Product / Process Change Notification (PCN)

PCN #: PCN_FeSTAR-BUENO_20230821

Affected Series: WE-STAR-BUENO;
 74275812; 74275812S
 74275813; 74275813S
 74275815; 74275815S

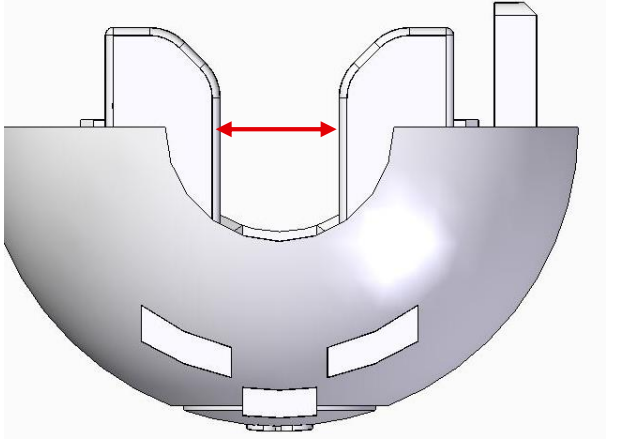
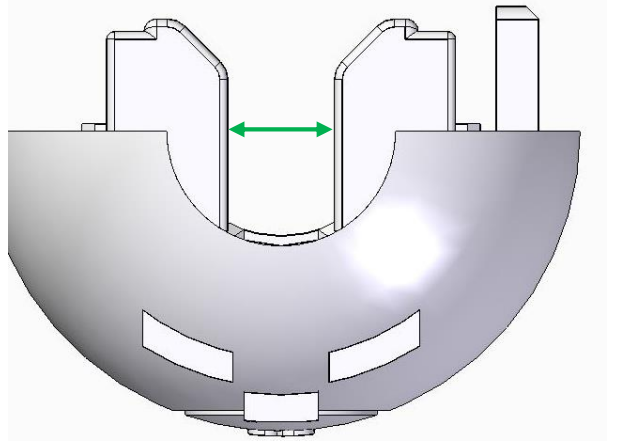
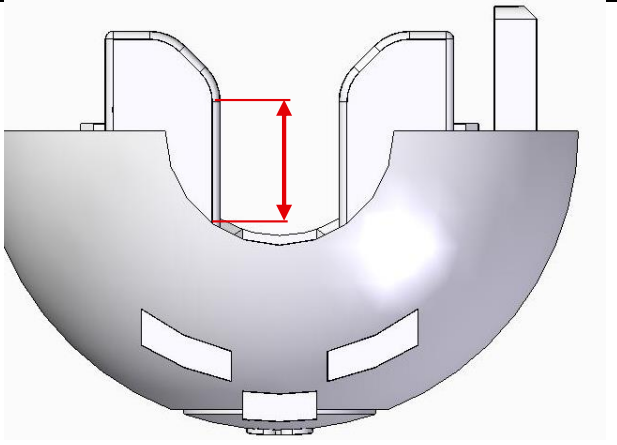
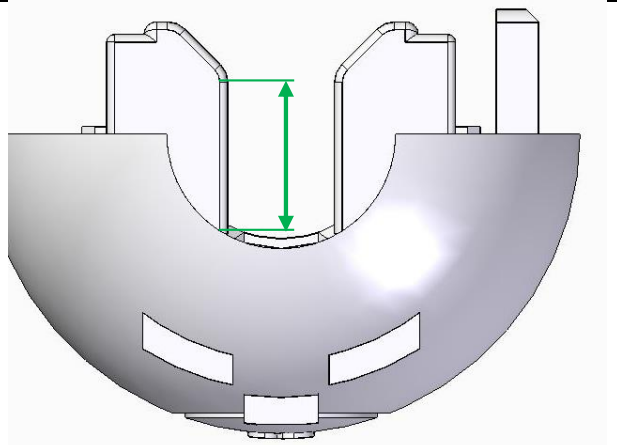
BEFORE CHANGE	AFTER CHANGE
Cables with an outer diameter at the lower limit of the applicable cable diameter could possibly not been fixed.	Improvements of the cable fixation elements to meet the data sheet specification of the applicable cable diameter.
 74275812(S): 2.40 mm 74275813(S): 4.80 mm 74275815(S): 4.80 mm	 Reduction of the distance between the cable fixation elements. 74275812(S): 2.25 mm 74275813(S): 4.25 mm 74275815(S): 4.25 mm
	 Increasing the height of the cable fixation elements to generate a larger clamping area for the cable.

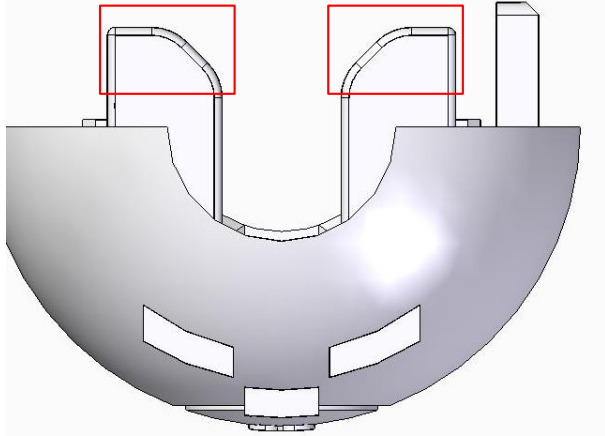
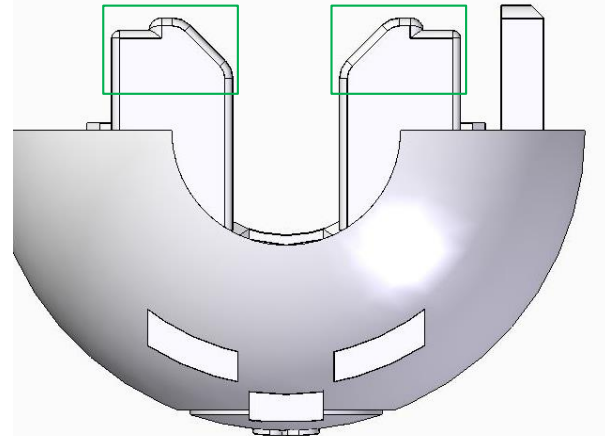
Flat top of the cable fixation elements. Notice: The part numbers 74275812 & 74275812S remain flat top cable fixation elements.	Change the form of the top of the cable fixation elements without influence to the function. Notice: This change is only valid for the part numbers 74275813; 74275813S; 74275815; 74275815S
Reliability / Qualification Summary: Product approval is according to the specification criteria and is internally released by the Product Management Department. The following items are part of the internal release process for this change: - Visual Appearance (Surface, Burr, Contaminations, ...) - Mechanical Parameters (according as specified in the Datasheet) - Approval of production line
